MEMORANDUM

SUBJECT: Construction of Wave Barrier, at 1301 Weston Lane North
File # SP-91-0142DS

PROJECT: WAVE BARRIER FOR EROSION CONTROL
(SHORELINE MODIFICATION FOR C. INOUE)

REVIEW COMMENTS

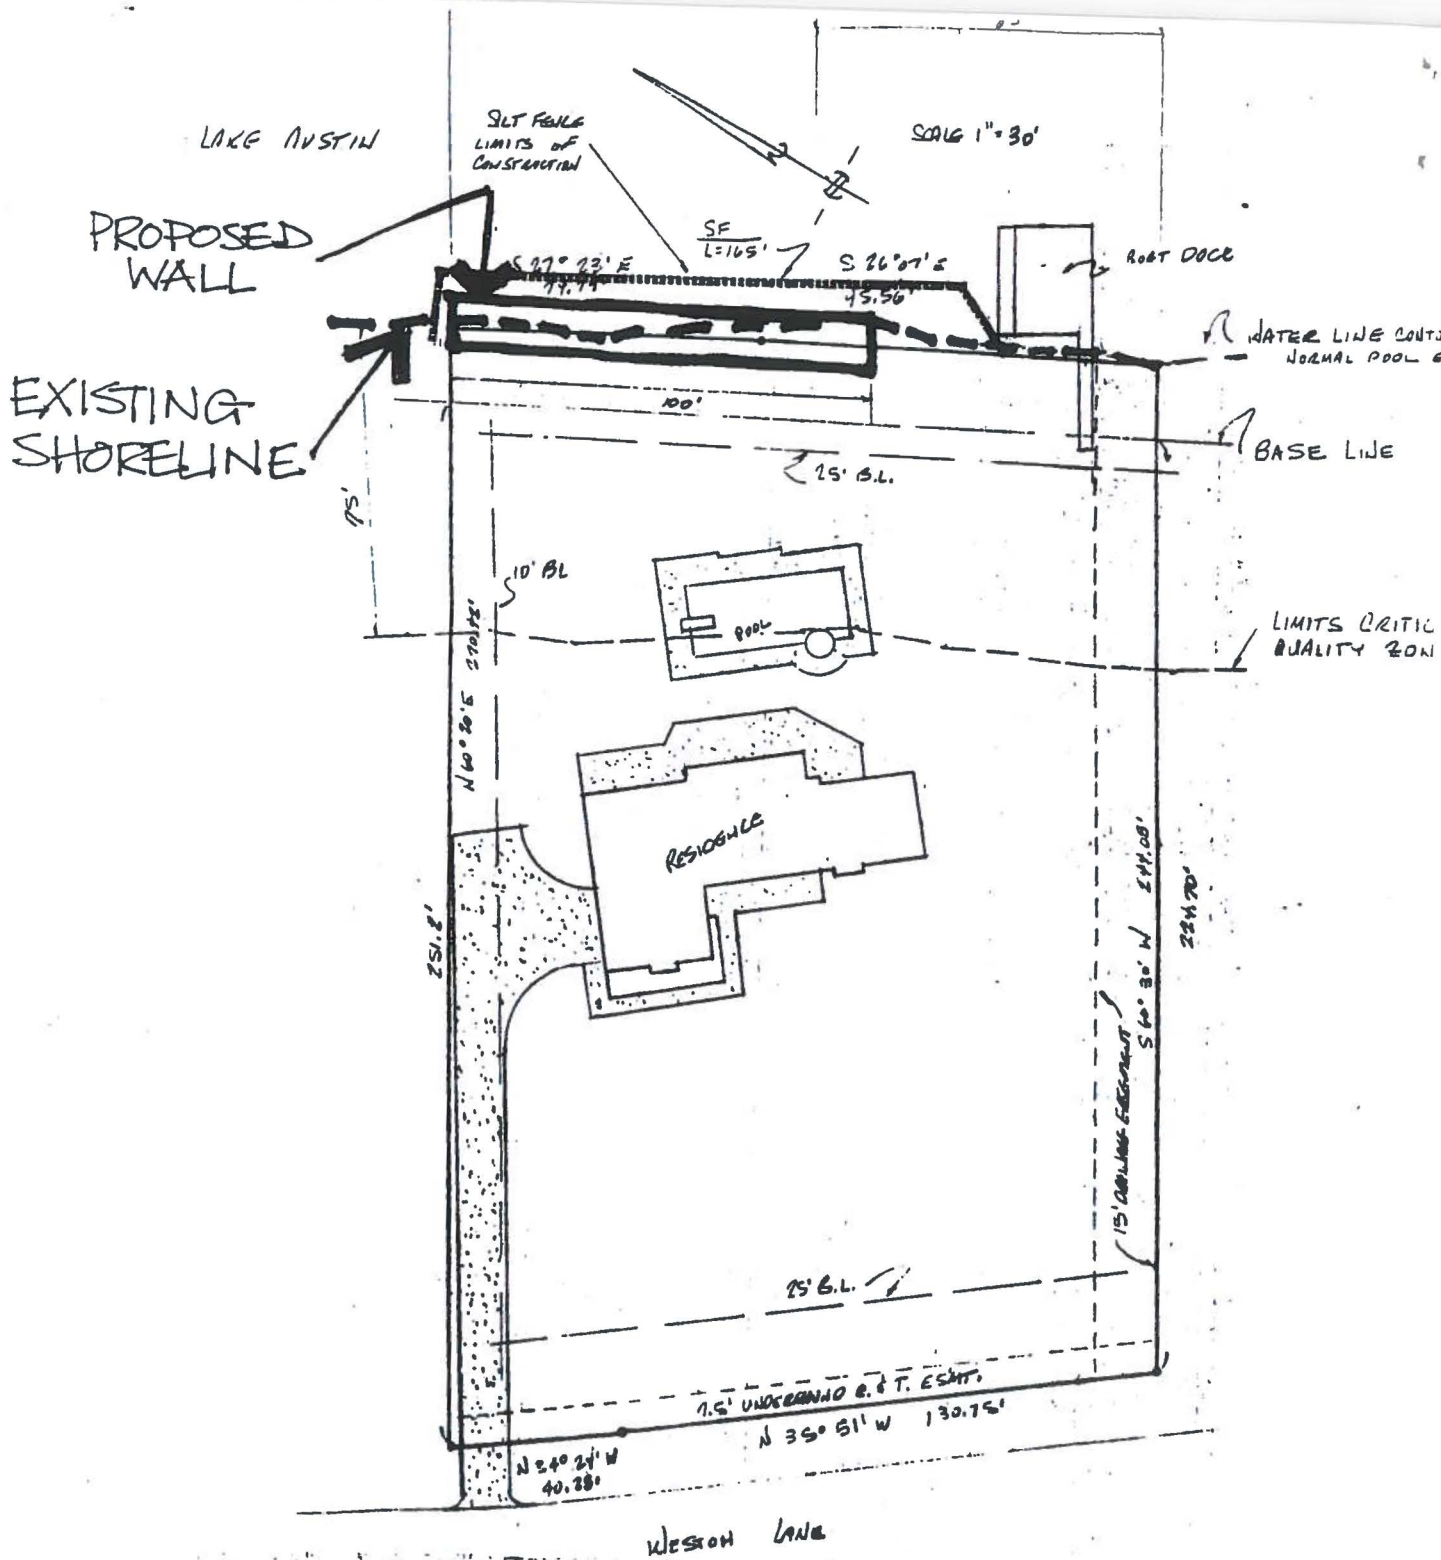
The proposal is to construct the wall straight for 85' although the shoreline is sinuous. To minimize encroachment into the water by the wall I recommend that the alignment of the wall should follow the existing shoreline.

D 2. The cross sections 'B' and 'C' appear to indicate that the toe of the wall will be constructed in front of the existing shoreline thus reclaiming additional land. Section 13-1-604(10) describes a small project as "Construction...of a retaining wall...with backfill that does not reclaim substantial land..." Will construction of this wall in the location indicated on the plan reclaim "substantial land"?

D 4. The shorelines of, and any improvements to the adjacent properties upstream and downstream of this location should be indicated. This proposed wall should tie into any improvements on the adjacent properties to prevent further erosion occurring at the ends of the walls.

1. The wall following the existing alignment of the shoreline to minimize encroachment into the water.
2. The ends of the wall are tied into any existing shoreline improvements on the adjacent properties.
